## MEYER SUBDIVISION

### 245 WALNUT STREET, LIBERTYVILLE, IL 60048

# PRELIMINARY ENGINEERING FOR MEYER SUBDIVISION

**PLANNING DIVISION COMMENTS:**

# TREE PROTECTION & REMOVAL PLAN MEYER SUBDIVISION

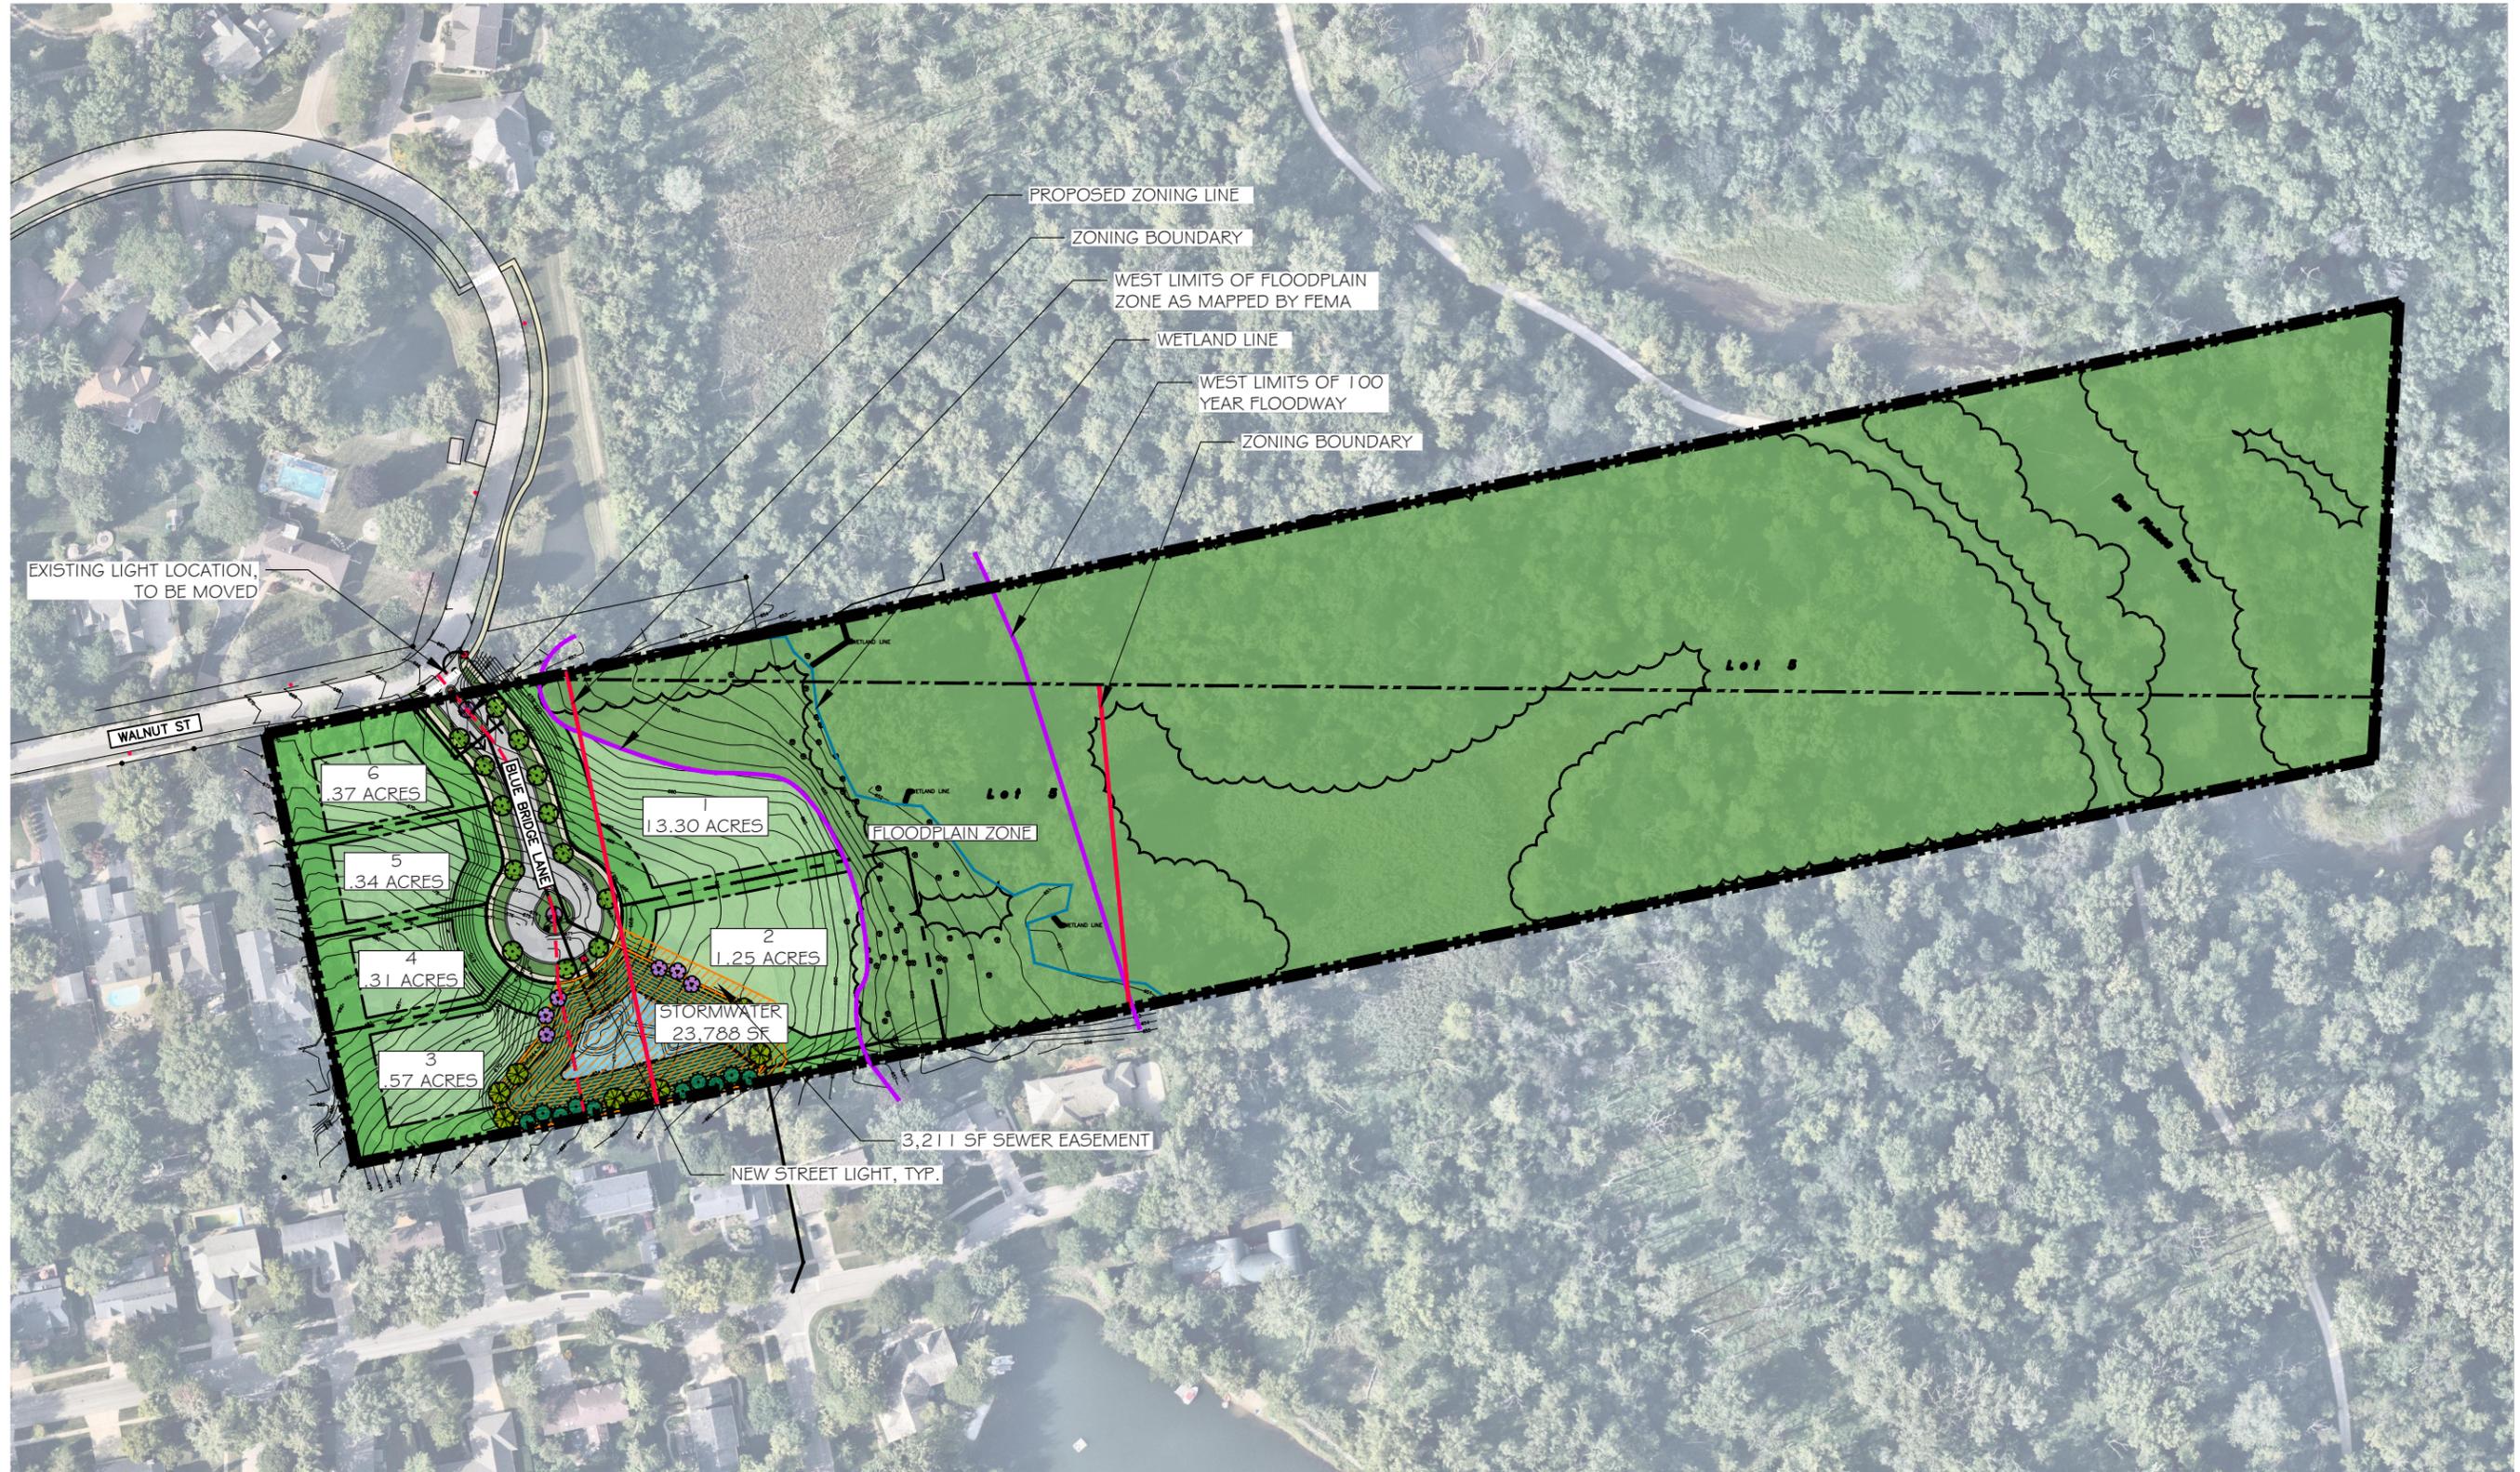
2. **Tree Removals** – As stated above, the general state of the ultimate condition for each residential lot will be approved as part of this subdivision, and this should include necessary tree removals. Please revise the plans to indicate which trees are expected to be removed as part of this proposed subdivision in order to accommodate home construction on each lot. Phasing can be proposed if the intent is that some trees remain during the first phase of

construction but are expected to be removed to accommodate the new homes eventually. Also, please make sure the tree removals are consistently shown on all drawings, including landscape plans and engineering plans.

Tree removals have been revised as requested.

**GRADING PLAN**

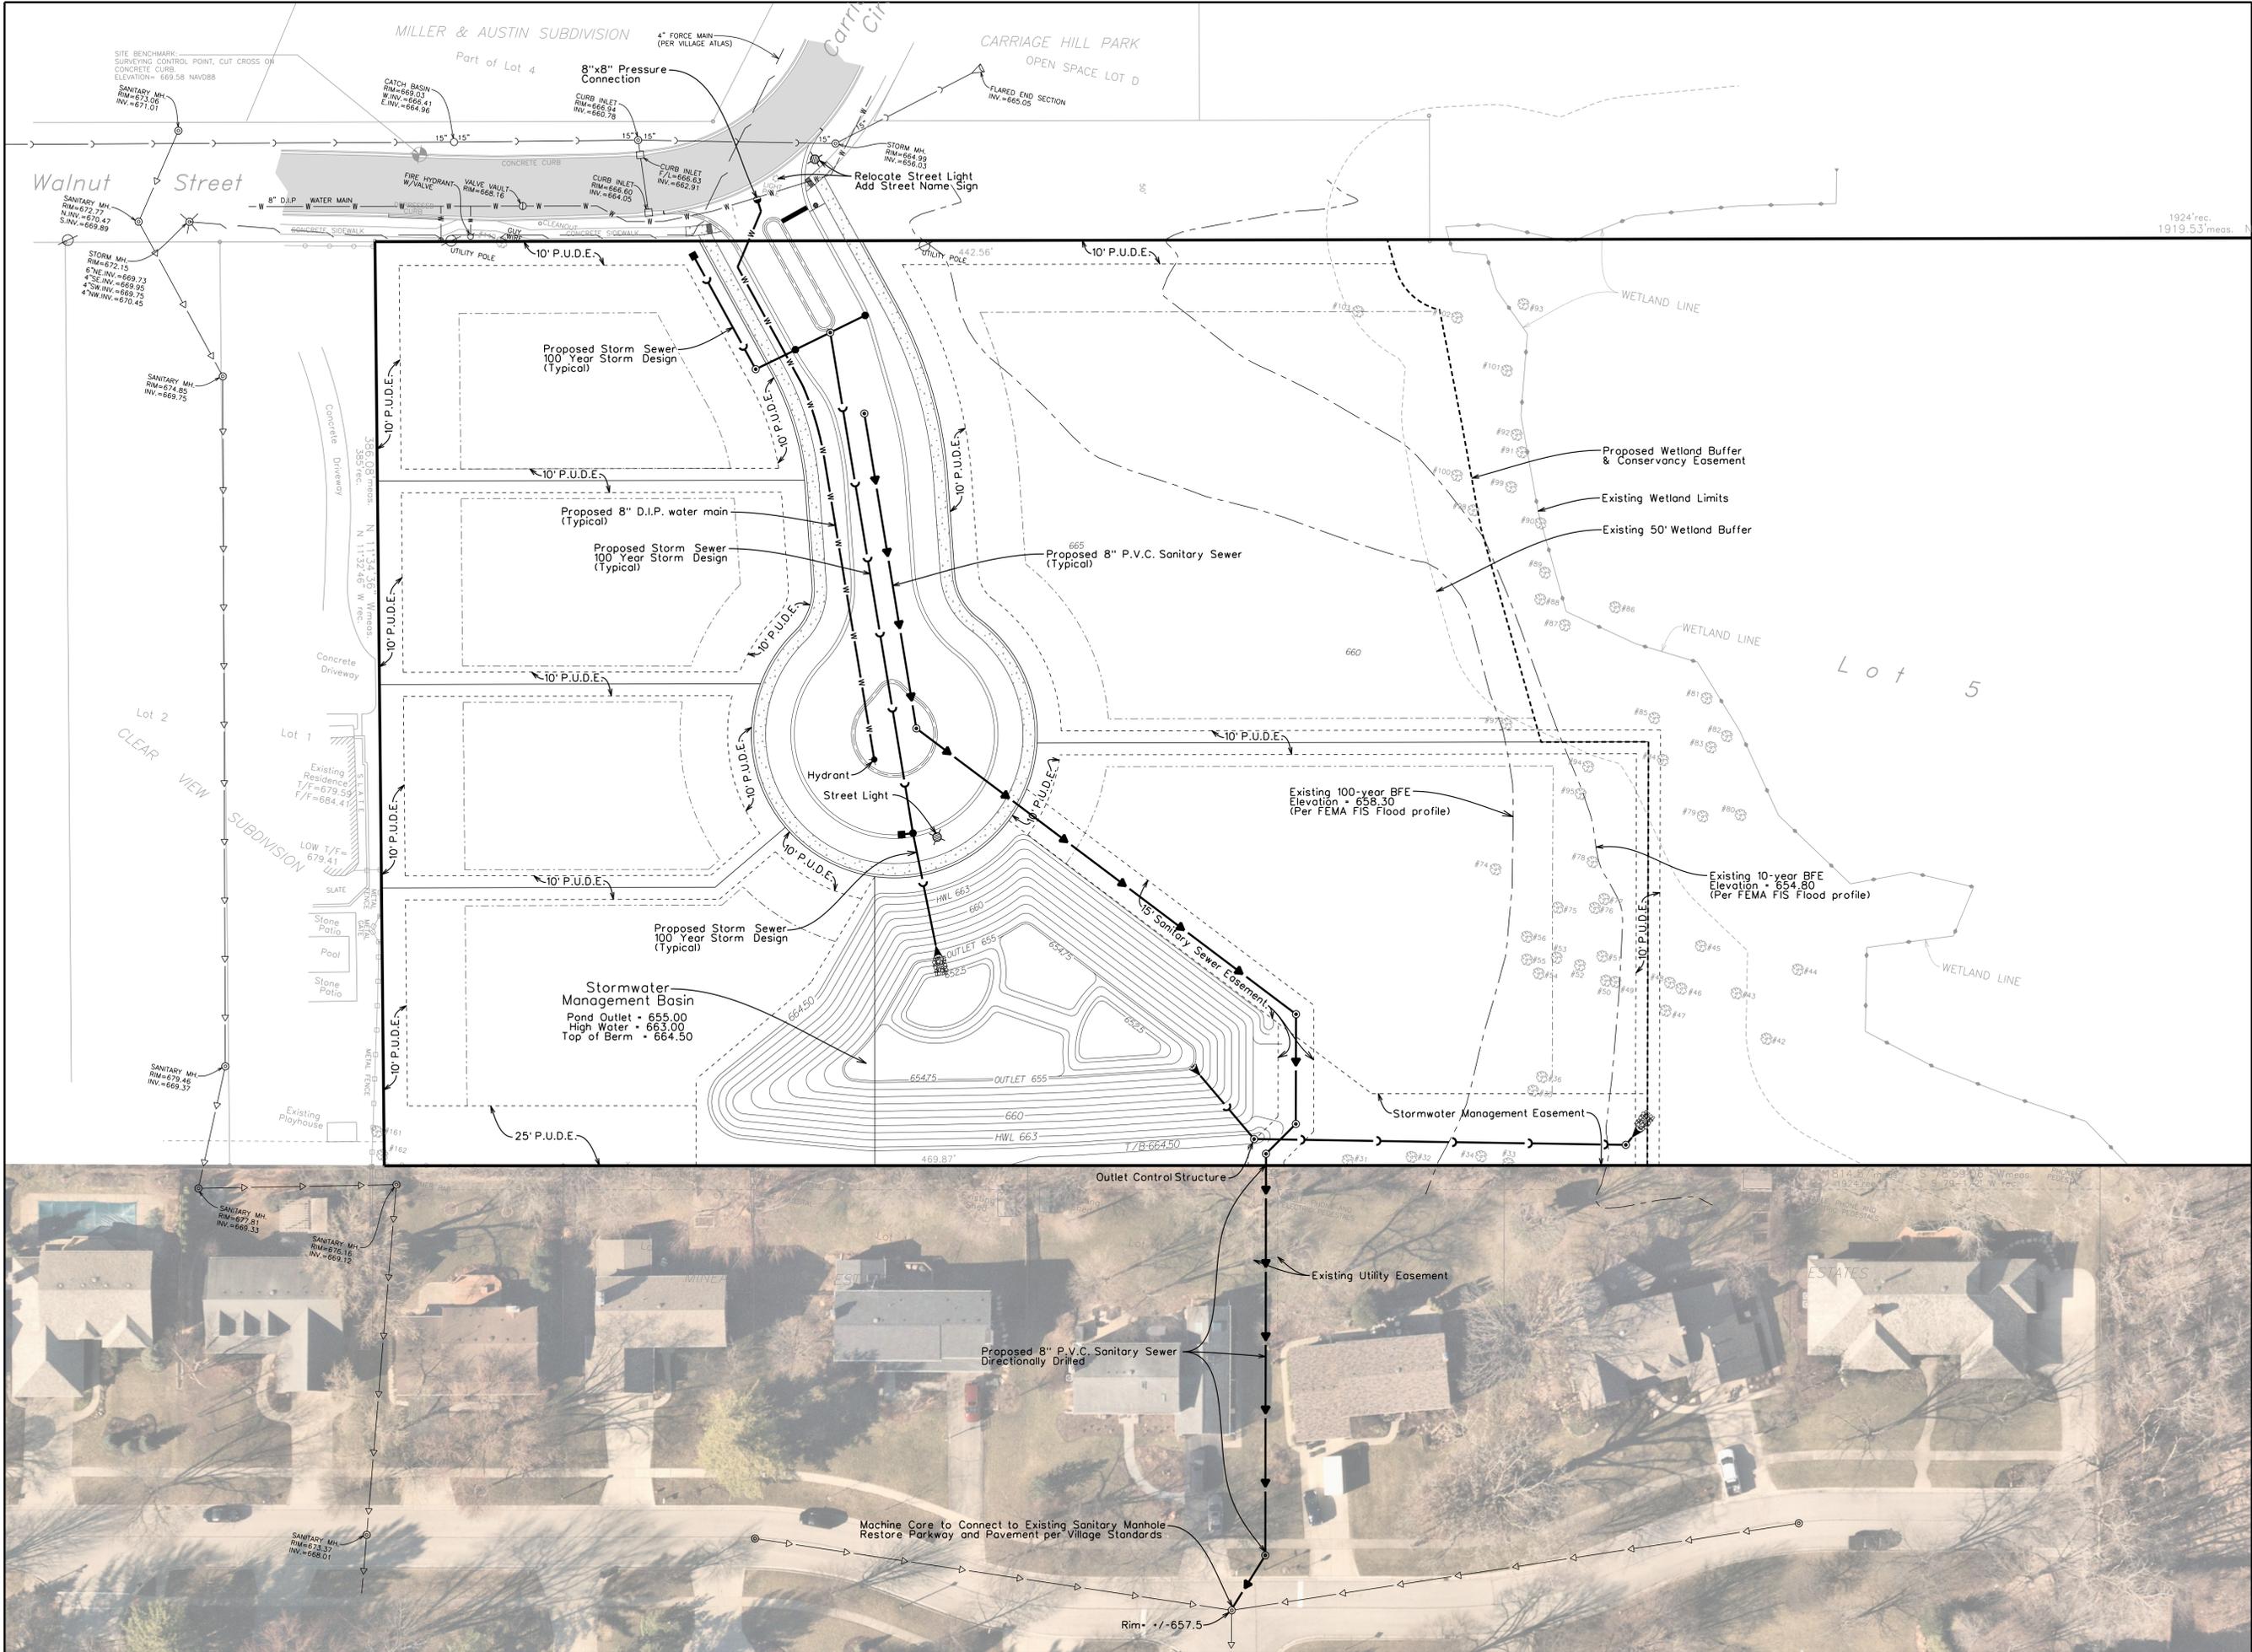
1. **Phasing and Residential Lot Grading** – The drawings submitted by the applicant show proposed residential lots 3, 4, 5, and 6 to remain in an undeveloped state, with steep slopes and existing trees that would need to be removed prior to the construction of homes on these lots. While staff would support appropriate project phasing, the review and approval for this proposed subdivision needs to confirm that the grading of each residential lot generally works with the design of the newly proposed public roadway and adjacent property. Additionally, it is unclear if Lot 1 can be developed without creating fill within the existing floodplain and/or meet Flood Protection Elevation requirements as set forth in the Lake County WDO. Therefore, the applicant should show all necessary improvements (including grading and approximate driveway location/slope) for each lot to be developed to the ultimate condition. Staff understands the homes on these lots will be designed individually in the future, and modifications can be submitted at that time for review and approval. However, the general functionality of each residential lot must be shown on the plans and approved with the subdivision.

1. Clarify the finished grade of the four (4) west lots be in comparison with the surrounding grade.  
**Conceptual building boxes and grading have been incorporated on Grading Sheet #5 (Refer to Engineering Division Comment #1).**
2. Clarify the proposed driveway slope of the four (4) west lots from street. There appears to be a 13 foot grade rise from street to building envelopes.  
**Conceptual driveway slopes have been added to the Grading Sheet #5.**

*Conceptual building boxes and grading have been incorporated on the Grading plan Sheet*

Year 2030 No-Build Traffic Volumes

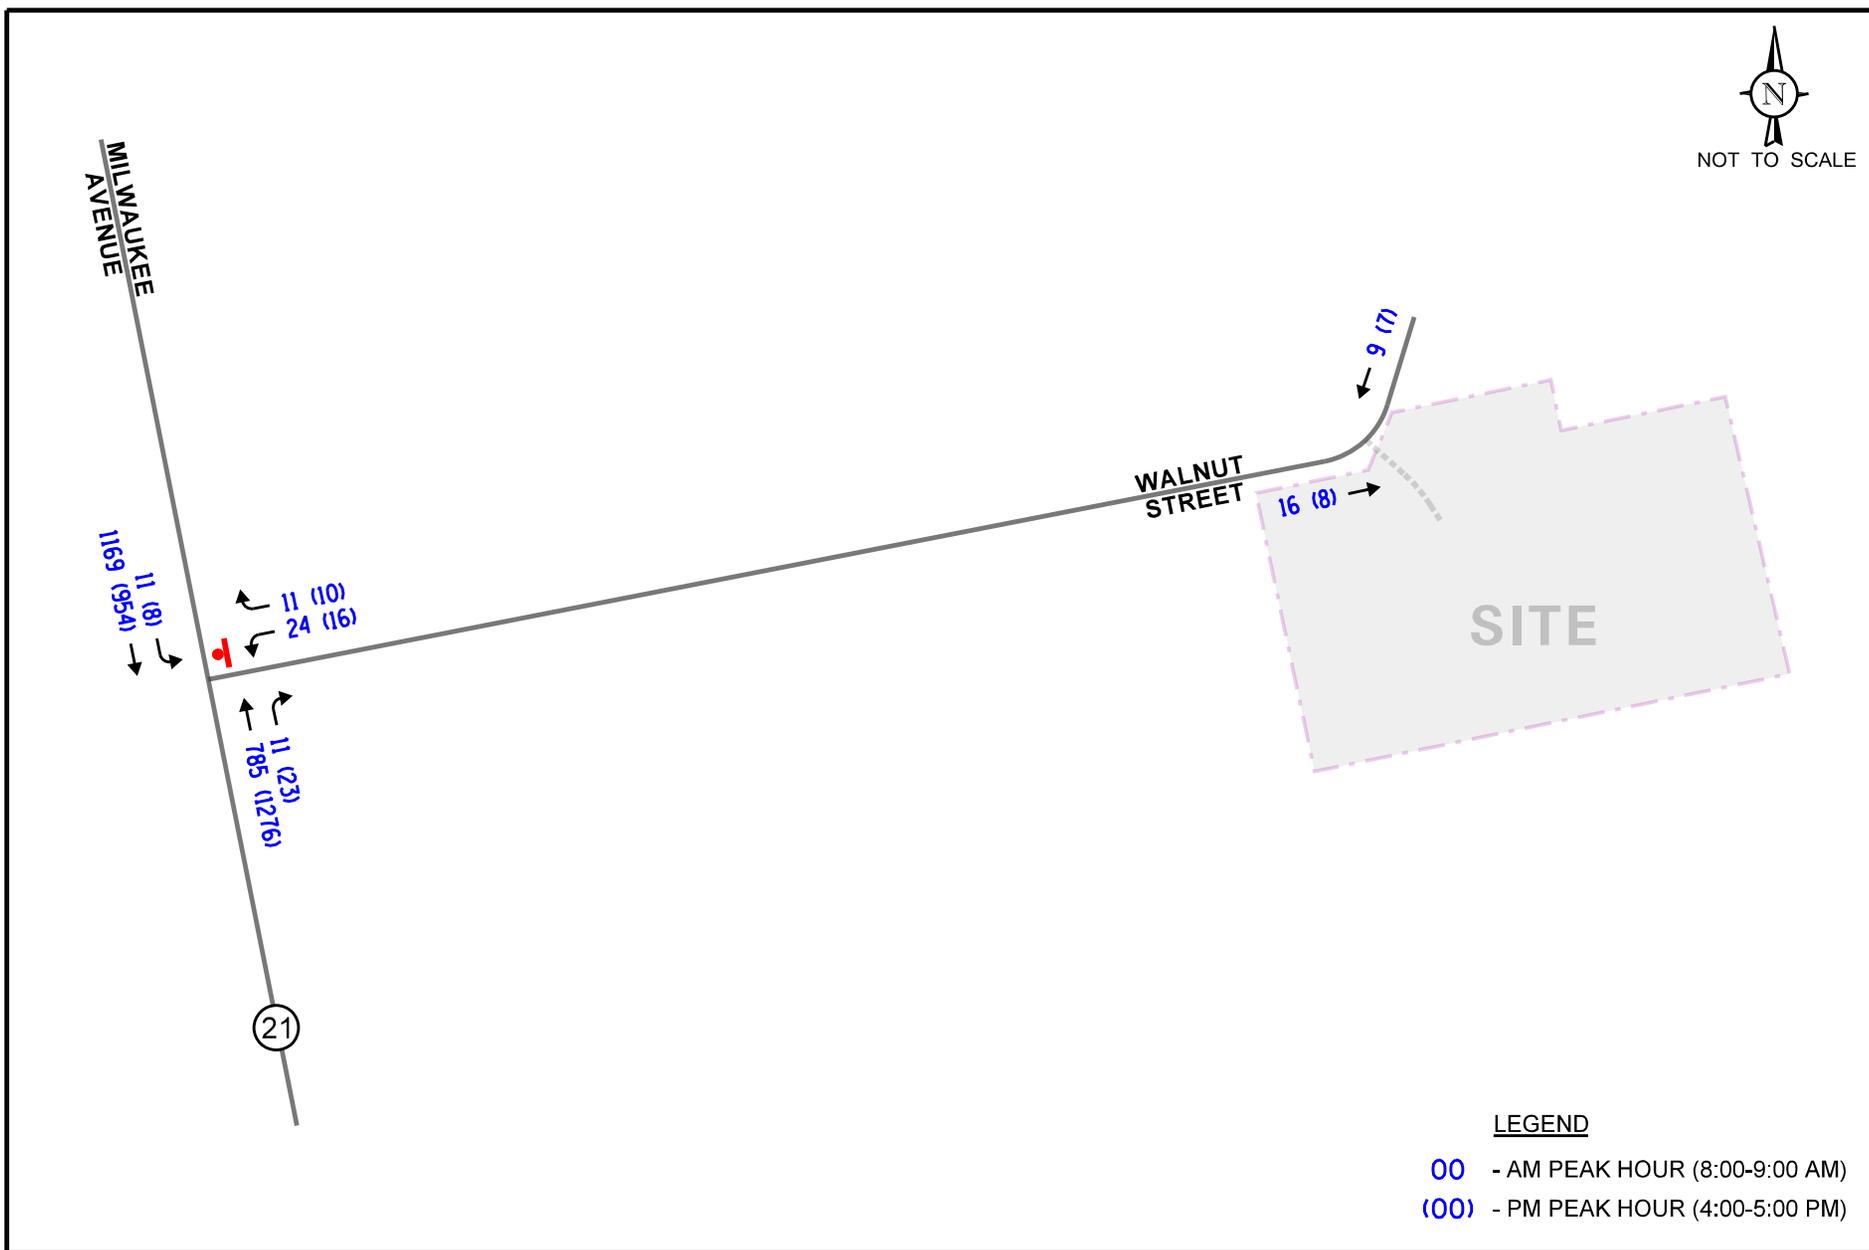
4. A figure showing the year 2030 background traffic on the network would be helpful in reviewing the accuracy of the background growth calculations.

**A figure showing the Year 2030 background traffic volumes has been included in the Appendix of the revised traffic study.**
